STM32L031xx/L041xx device errata

Applicability

This document applies to the part numbers of STM32L031xx/L041xx devices and the device variants as stated in this page. It gives a summary and a description of the device errata, with respect to the device datasheet and reference manual RM0377. Deviation of the real device behavior from the intended device behavior is considered to be a device limitation. Deviation of the description in the reference manual or the datasheet from the intended device behavior is considered to be a documentation erratum. The term “*errata*” applies both to limitations and documentation errata.

2.8.3 LPTIM events and PWM output are delayed by 1 kernel clock cycle

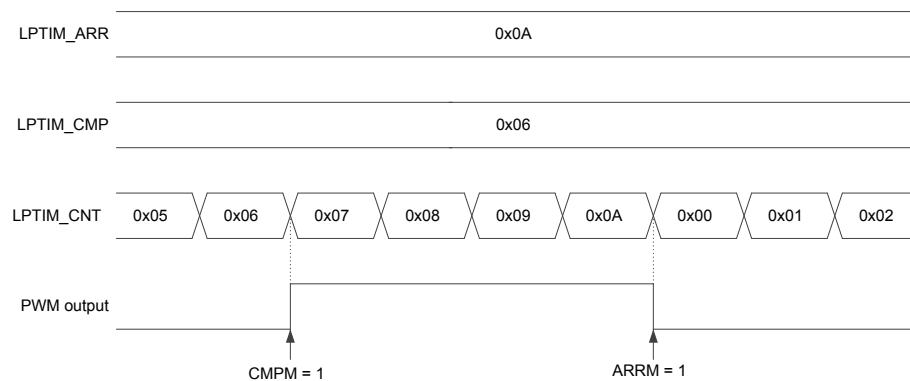
The compare match event (CMPM), auto reload match event (ARRM), PWM output level and interrupts are updated with a delay of one kernel clock cycle.

Consequently, it is not possible to generate PWM with a duty cycle of 0% or 100%.

The following waveform gives the example of PWM output mode and the effect of the delay:

Set the compare value to the desired value minus 1. For instance in order to generate a compare match when LPTM_CNT = 0x08, set the compare value to 0x07.

Figure 1. Masked RTC interrupt

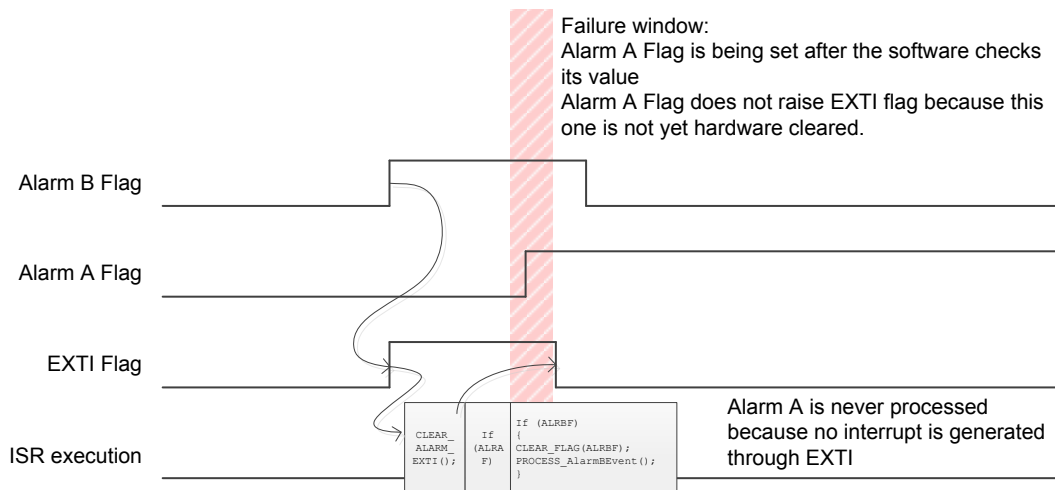
One RTC interrupt request can mask another RTC interrupt request if they share the same EXTI configurable line. For example, interrupt requests from Alarm A and Alarm B or those from tamper and timestamp events are OR-ed to the same EXTI line (refer to the *EXTI line connections* table in the *Extended interrupt and event controller (EXTI)* section of the reference manual).

The following code example and figure illustrate the failure mechanism: The Alarm A event is lost (fails to generate interrupt) as it occurs in the failure window, that is, after checking the Alarm A event flag but before the effective clear of the EXTI interrupt flag by hardware. The effective clear of the EXTI interrupt flag is delayed with respect to the software instruction to clear it.

In the interrupt service routine, apply three consecutive event flag checks - source one, source two, and source one again, as in the following code example:

```
void RTC_Alarm_IRQHandler(void)
{
    CLEAR_ALARM_EXTI(); /* Clear the EXTI's line Flag for RTC Alarm */
    If(ALRAF) /* Check if AlarmA triggered ISR */
    {
        CLEAR_FLAG(ALRAF); /* Clear the AlarmA interrupt pending bit */
        PROCESS_AlarmAEvent(); /* Process AlarmA Event */
    }
    If(ALRBF) /* Check if AlarmB triggered ISR */
    {
        CLEAR_FLAG(ALRBF); /* Clear the AlarmB interrupt pending bit */
        PROCESS_AlarmBEvent(); /* Process AlarmB Event */
    }
    If(ALRAF) /* Check if AlarmA triggered ISR */
    {
        CLEAR_FLAG(ALRAF); /* Clear the AlarmA interrupt pending bit */
        PROCESS_AlarmAEvent(); /* Process AlarmA Event */
    }
}
```
